<b>JRPP No</b>	<b>2011SYW044</b>
<b>DA Number</b>	<b>DA0110/11</b>
<b>Local Government Area</b>	<b>Ku-ring-gai Council</b>
<b>Proposed Development</b>	<b>Demolition of existing dwellings and construction of two residential flat buildings comprising 43 units, landscaping and associated works.</b>
<b>Street Address</b>	<b>6A &amp; 8 Buckingham Road Killara</b>
<b>Applicant/Owner</b>	<b>Aleksandar Design Group Pty Ltd</b>
<b>Number of Submissions</b>	<b>10</b>
<b>Recommendation</b>	<b>Refusal</b>
<b>Report by</b>	<b>Jonathan Goodwill, Executive Assessment Officer</b>

## SUMMARY SHEET

<b>REPORT TITLE:</b>	6A & 8 Buckingham Road, Killara
<b>LOT &amp; DP:</b>	Lot 3 & 4 DP 414101 (6A Buckingham Road) Lot 1 DP 414101 (8 Buckingham Road)
<b>PROPOSAL:</b>	Demolition of existing dwellings and construction of two residential flat buildings comprising 43 units, landscaping and associated works.
<b>DEVELOPMENT APPLICATION:</b>	DA0110/11
<b>WARD:</b>	Gordon
<b>APPLICANT:</b>	Aleksandar Design Group Pty Ltd
<b>OWNER:</b>	<ul style="list-style-type: none"><li>- 6A Buckingham Road: Mrs C A M Grundy</li><li>- 8 Buckingham Road: Mr J T L Gilroy and Mrs F M Gilroy</li></ul>
<b>DATE LODGED:</b>	10 Mar

**Figure 1 - when measured from the finished ground level of the courtyard of apartment 4 the wall plane has an area of 174m<sup>2</sup> before stepping back at the top floor level. This wall plane includes the open terrace on Level 2 and three balconies on Levels 3-5.**

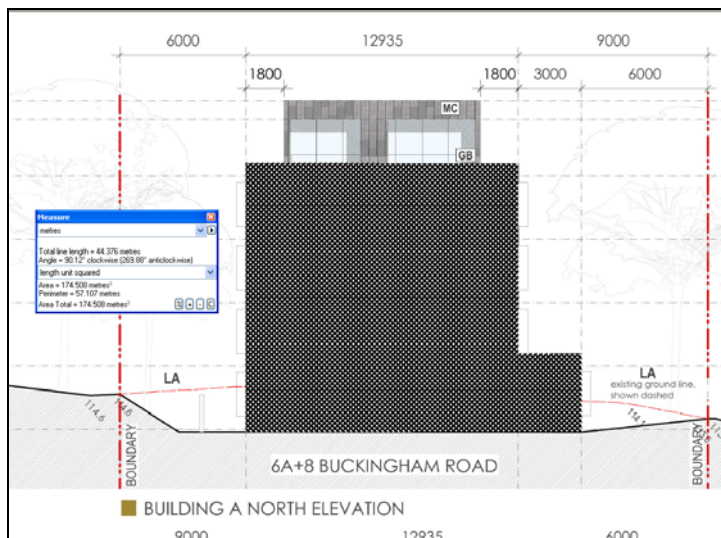
The variation to the wall plane depth and wall plane area controls is unacceptable because the development fails to achieve a visual connection between the dwellings and the public domain and the elements of the articulation do not have a strong relationship to the characteristics of existing buildings in the area. The primary concern is that the development fails to include a pedestrian entry that is visible from the street. The development could be improved by incorporating a pedestrian entry into the centre of Level 3. This option would avoid the need for a stair ascender at the side of the building and an access ramp could be centrally located in the front setback area. This option would give the development a clear identity and street address whilst improving safety through minimising entrapment and concealment spaces.
